Supplement to

MAJOR HAVOC™

Conversion Instructions for Tempest™ (TM-267, 1st Printing)

The following changes affect Figure 17–Deflection PCB Schematic (Version 4).

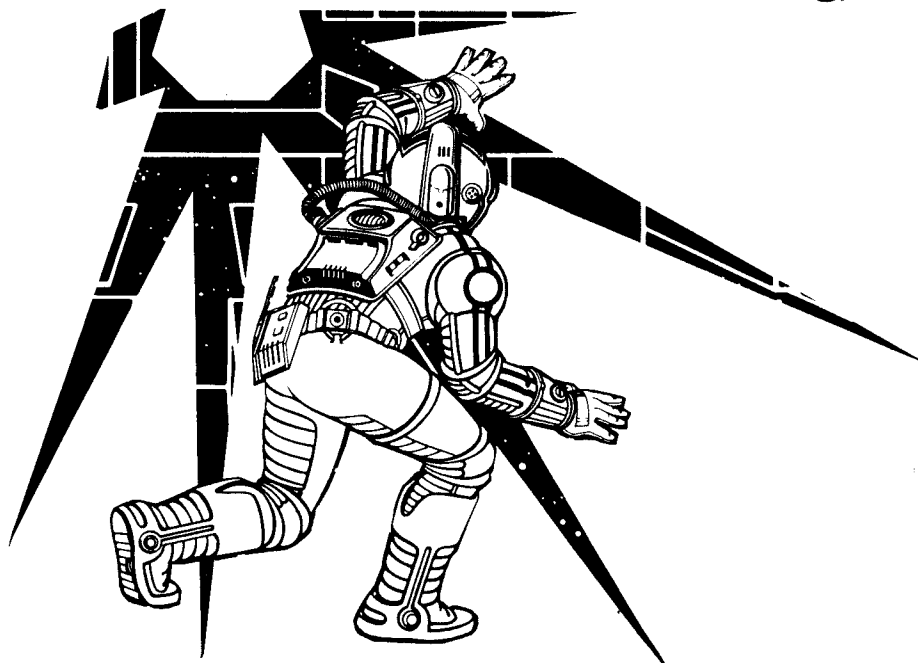
- Page 43.** Delete the two 1N4002 diodes from transistors Q102 and Q103.
- Page 43.** Add two 1N4002 diodes between the emitter and collector of transistors Q705 and Q706 as follows:

From:

To:
